CHANGE ORDER

PROJECT:
Willie Melton Paving and Drainage Improvements

CHANGE ORDER NUMBER 01
DATE 10/25/2017
PROJECT NUMBER 13115
CONTRACT FOR 828,014.00
CONTRACT DATE 7/11/2017
FBC PURCHASE ORDER NO 154483

Revise Contract Bid Item Quantities as Necessary to Complete the Work, Add Bid Item for Filter Fabric Fence (2,348 LF) and Long Side Water Service Connections (6Ea.) Necessary to Complete the work, and Add 3 Calendar Days to the Project Duration.

Long side water service (6 Ea.)

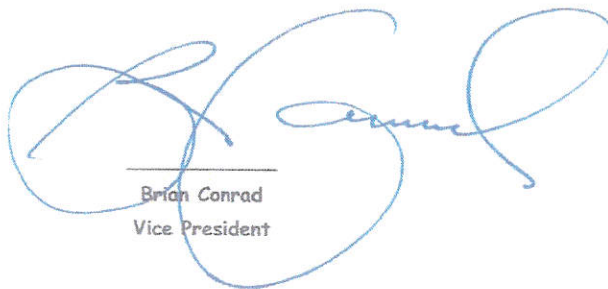
While breaking existing pavement (before we started removing it) we have already encountered and broken a long side water service at sta. 9+50 (picture attached). This service was only 1" - 2" below existing pavement. We had to make a repair but the line is in conflict with proposed paving and subgrade. What are we to do with water services in conflict with proposed pavement/subgrade? Lower the existing or install new services at lower elevation? There are no provisions for water line work in this contract. Please advise.

Install new services at a lower elevation and provide a proposal for this work.

Price includes single 1" long service split to two 3/4" single services including 6"x1" saddle with corporation and cut off, 1" poly line, and curb stop to meter w/ labor and equipment and remove/dispose old service (per typical detail provided)
Services to be install half of the roadway at a time
3 working days
Work will require removing and replacing a wooden fence
extra long services (approximately 50 LF / EA)
